***Technical Committee on  
Hanging and Bracing of Water-Based  
Fire Protection Systems***

**MEMORANDUM**

**SUBJECT:** **AUT-HBS AGENDA PACKAGE – A2012 ROC Meeting**

**PART 8 – ANNUAL 2012 PUBLIC COMMENTS  
AUT-HBS**

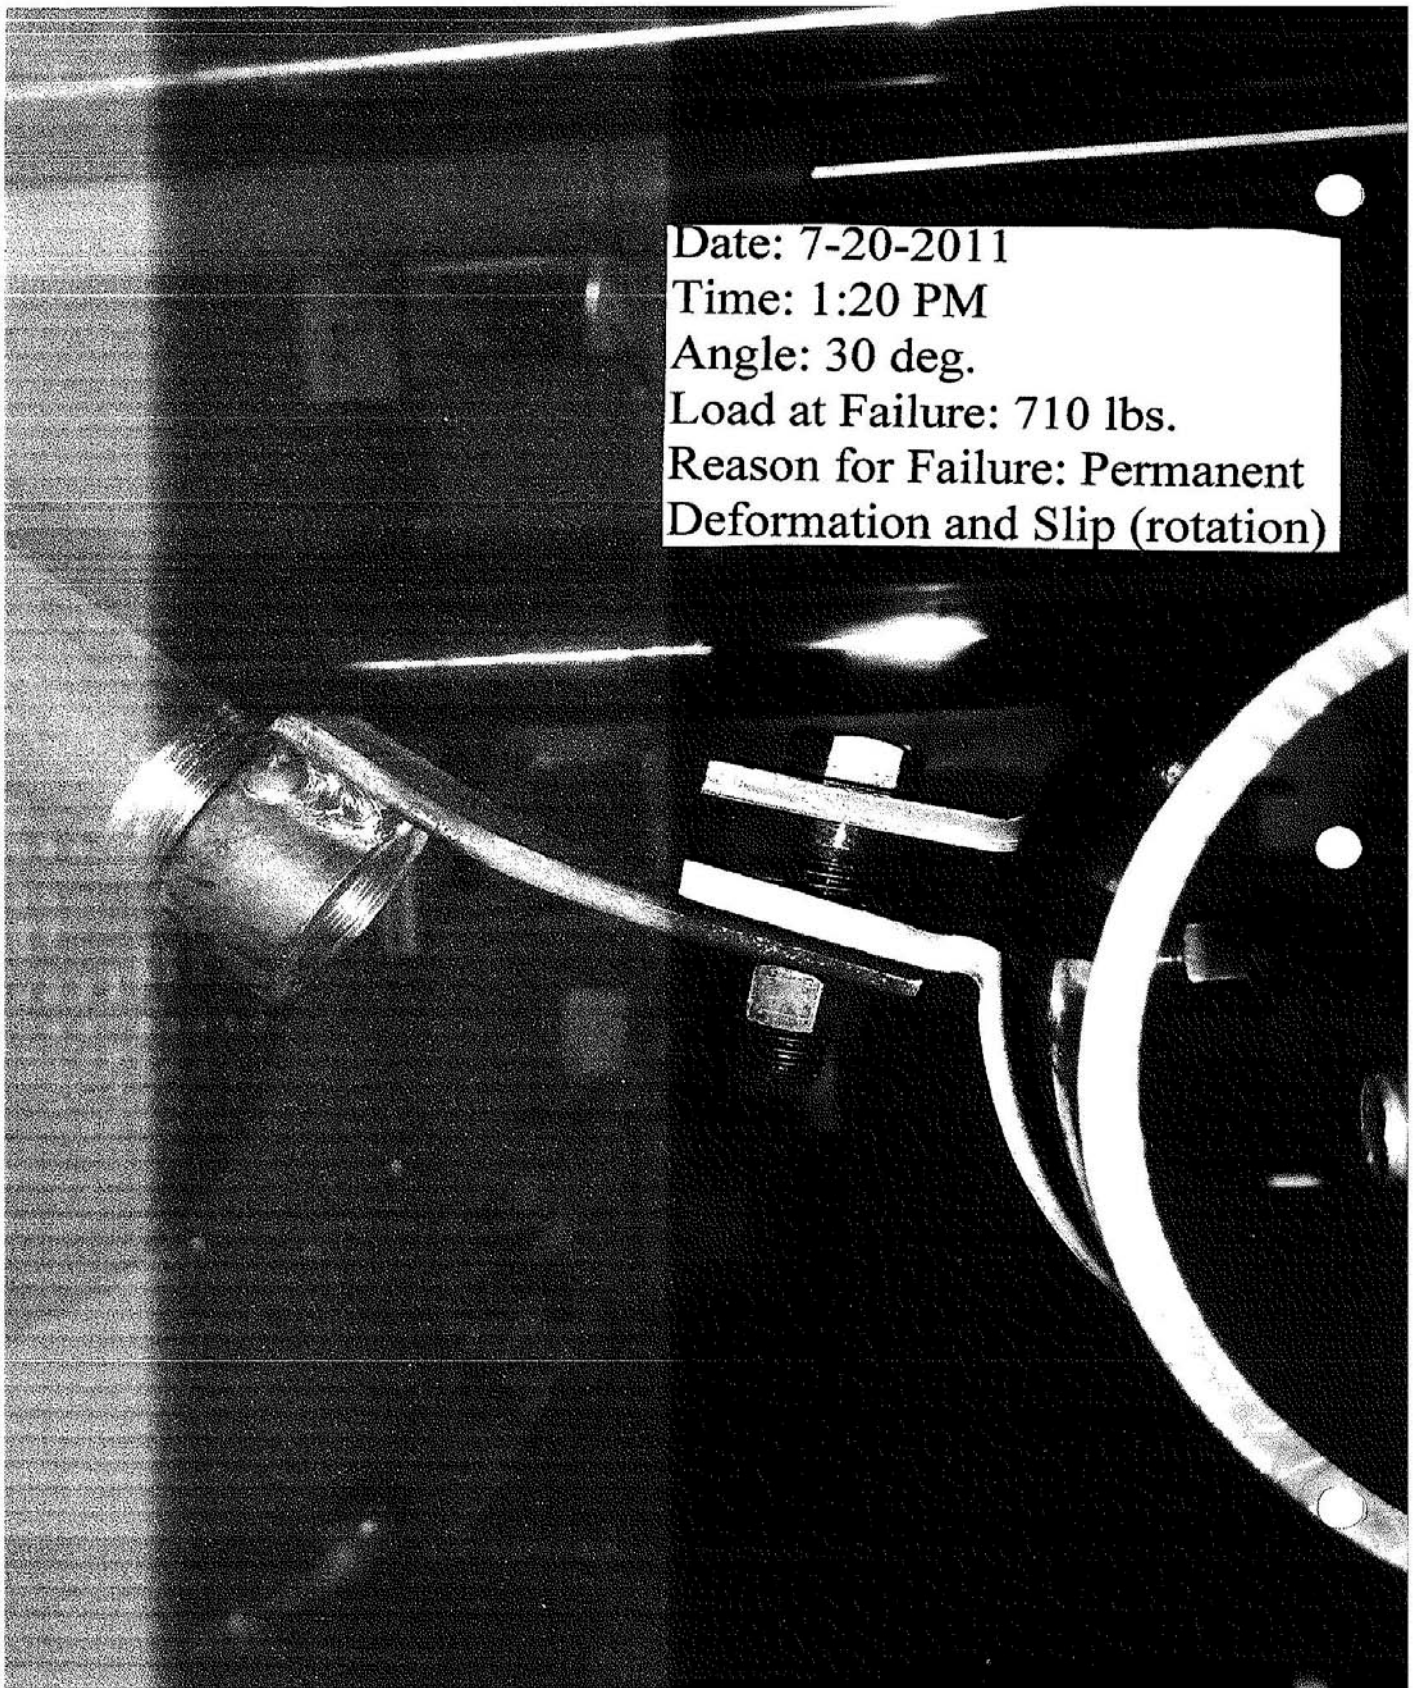
Recommendation: Additional documentation regarding existing proposed text at 9.3.5.2.2.

“...tested for listing at maximum eccentricity.”

13\_L1\_Figure #2\_S

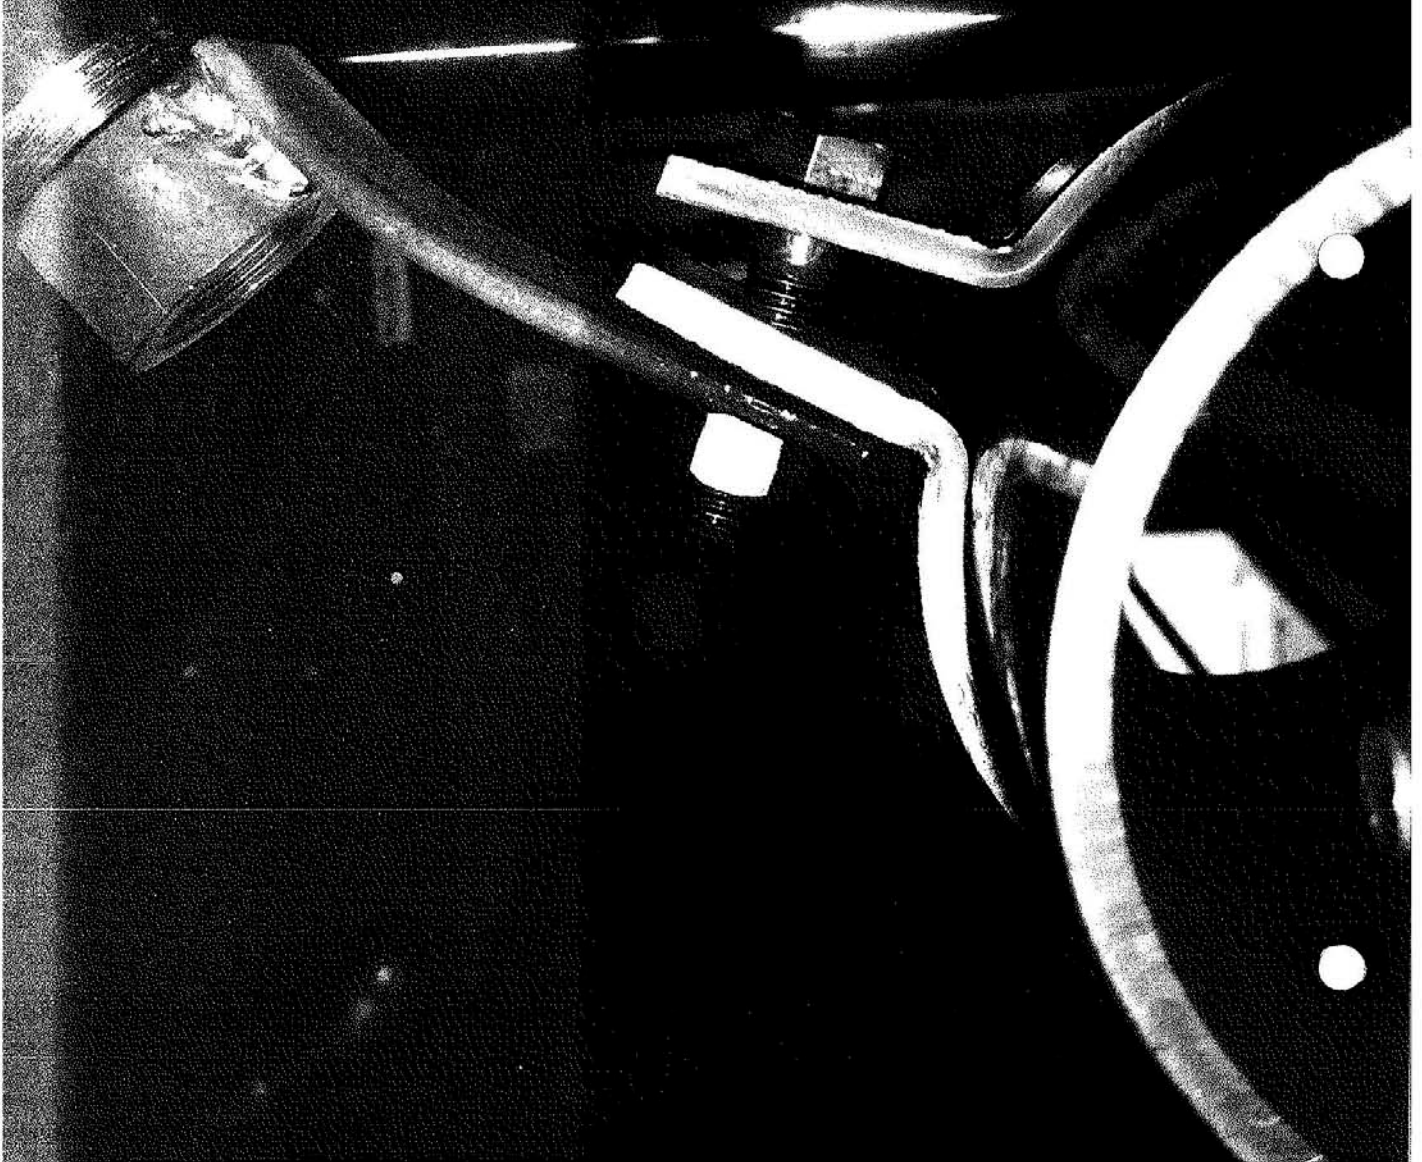
Substantiation: See two additional figures below.

Date: 7-21-2011  
Time: 2.00 PM  
Angle: 45 deg.  
Load at Failure: 980 lbs.  
Reason for Failure: Permanent  
Deformation and Slip (Rotation)
